# AMPEX

SERVICE BULLETIN

DATE: 20 March 1953  
MODEL: 300  
BULLETIN NO: 2  
PAGE NO: 1

### ELECTRONIC CIRCUIT MODERNIZATION

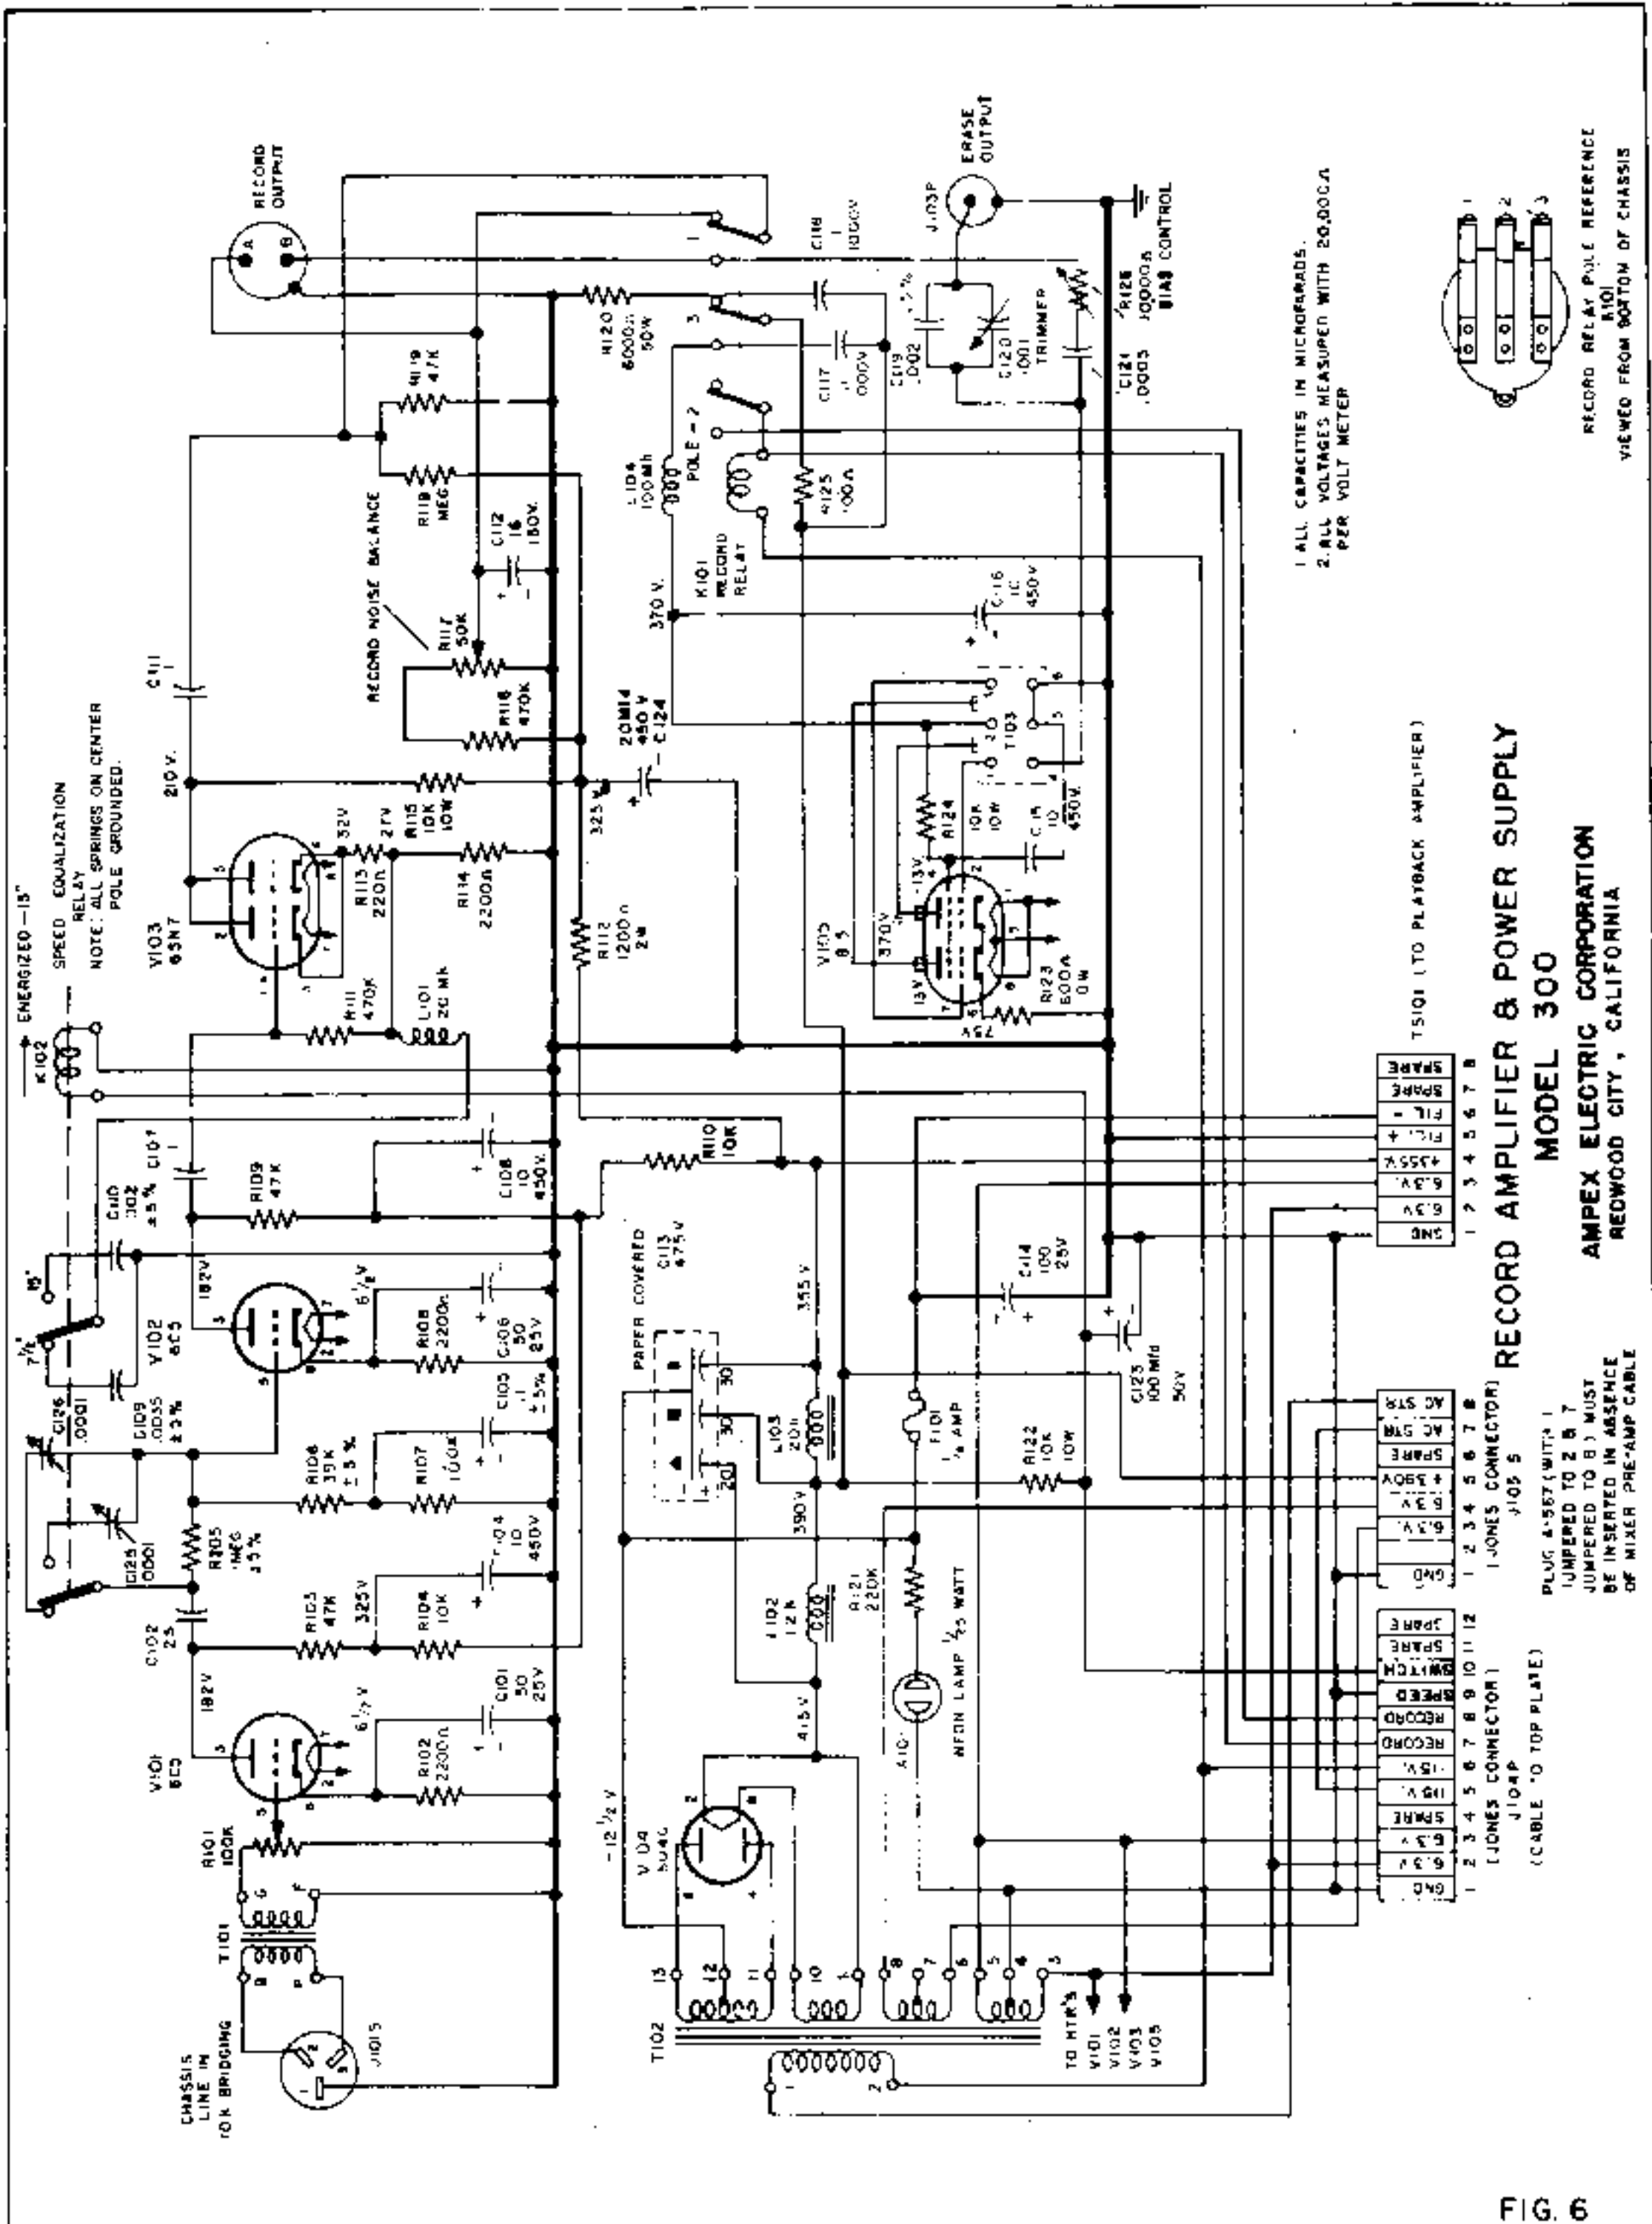
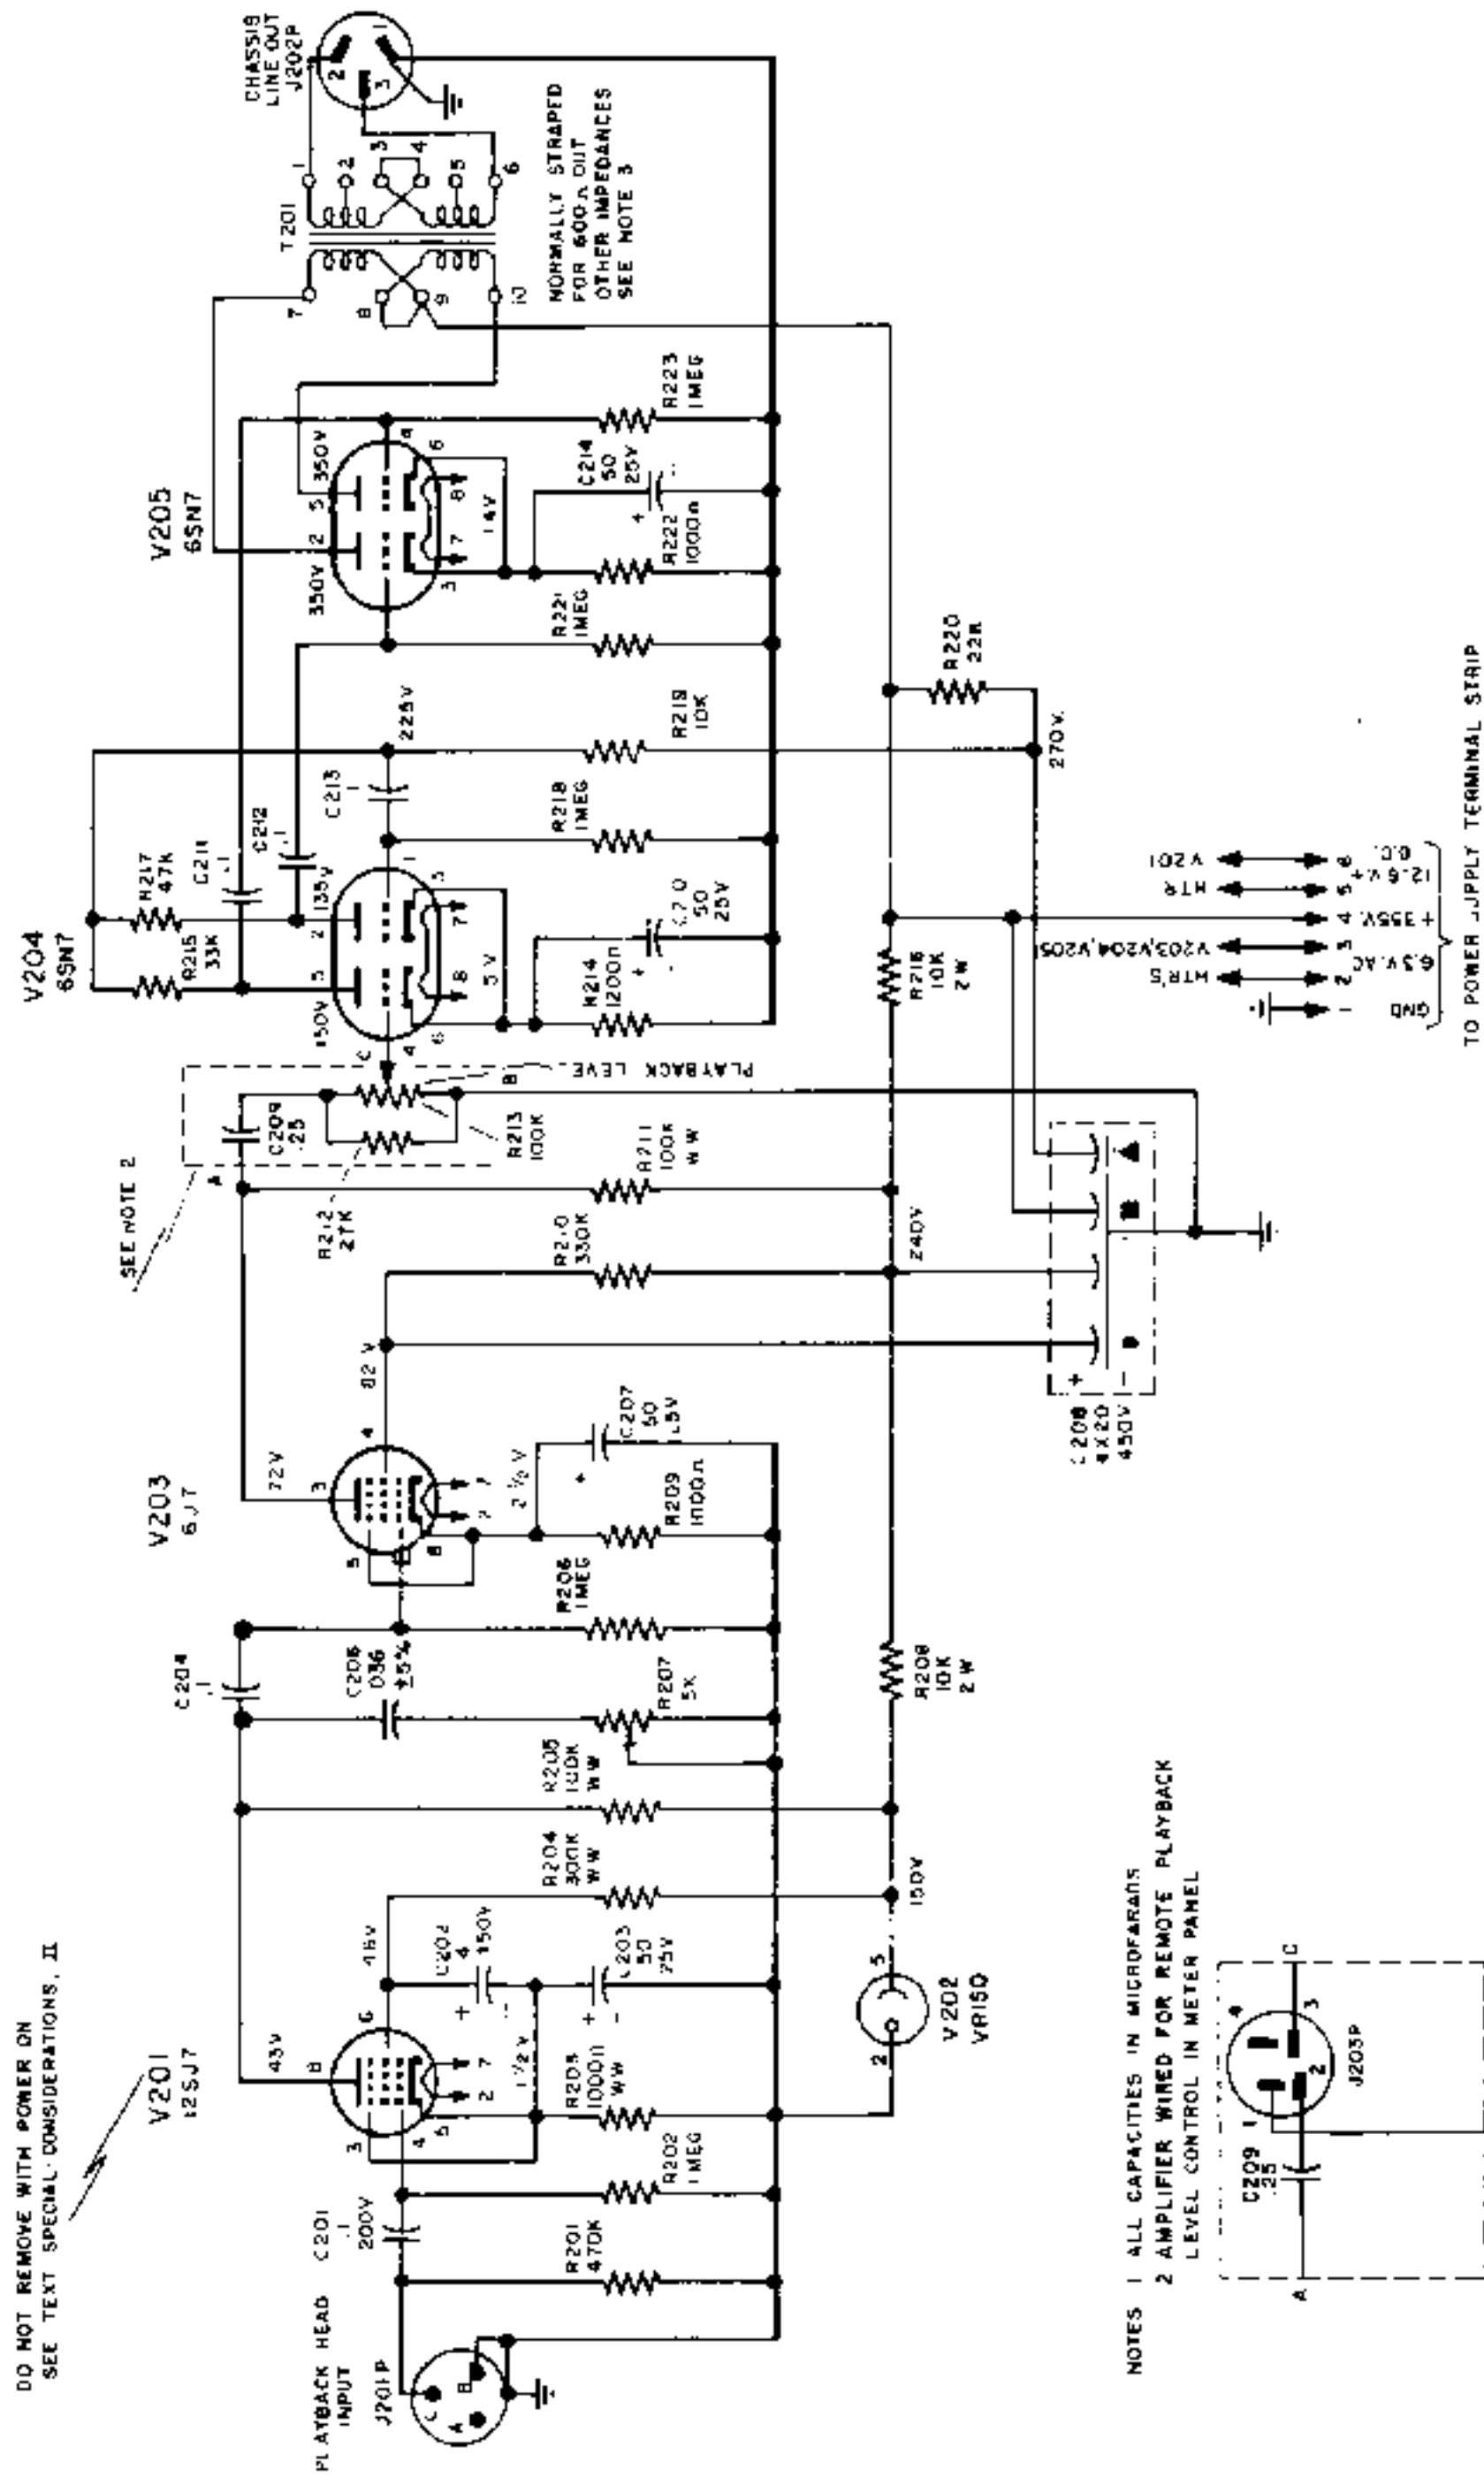
F. If the earlier Model 300 recorders are to be converted to take full advantage of the improved performance possible with present tapes and also to have extended range  $7\frac{1}{2}$ " response, the following changes in the record and playback electronics will have to be made depending upon the serial number category of the recorder:

1. The playback equalization circuitry in the grid stage of V203 must be changed to that circuitry shown on the attached playback amplifier diagram. Discard the old R207, 470,000 ohm resistor. The new R207 is a 5,000 ohm potentiometer, Ampex Catalog #RE-273. Discard the old C206, a .006 condenser and substitute the new C206, a .036 condenser, Ampex Catalog #CO-111. Rewire these parts in accordance with the playback amplifier schematic attached.

(Refer to record amplifier diagram for the following steps)
2. In the record amplifier, R106 must be changed to a 39,000 ohm  $\pm 5\%$  1 watt resistor. This resistor is Catalog #RE-44.

3. Condenser C123, a 100 mfd 50 volt condenser, Catalog #CO-63, must be added as shown on diagram.
4. Relay K102, Catalog #RL-2, should be added as shown. On J104P jumper terminals 1 and 9. Lead from R122 to terminal 2 on J105 should be reconnected to terminal 10 on J104P. Disconnect lead to terminal 10 on J104P from C109 (for this change compare new schematic with schematic furnished with original instruction book.)

5. Wire lead from bottom side of L101 to one outside rotor contact of J102. Connect to stator contacts of this section of the relay the new C109, Catalog #CO-10, and C110, Catalog #CO-21, condensers as shown.

6. Connect rotor of other outside relay section to the point between C102 and R105. Add the new trimmers C125 and C126, both bearing Catalog #CO-92, to stator contacts of this section as shown on attached diagram.

- Fig. 6 - 9-3-52 - Record Amplifier & Power Supply
- Fig. 8 - 1-2-51 - Playback Amplifier
- Fig. 16- 9-5-52 - Record Amplifier Response Curves
- Fig. 17- 9-5-52 - Playback Amplifier Response Curves
- Service Bulletin #19 - Parts List - 9-26-52
- Specification Section 1 Page 1 - 2-29-52
- Specifications Section 1 Page 2 - 2-29-52
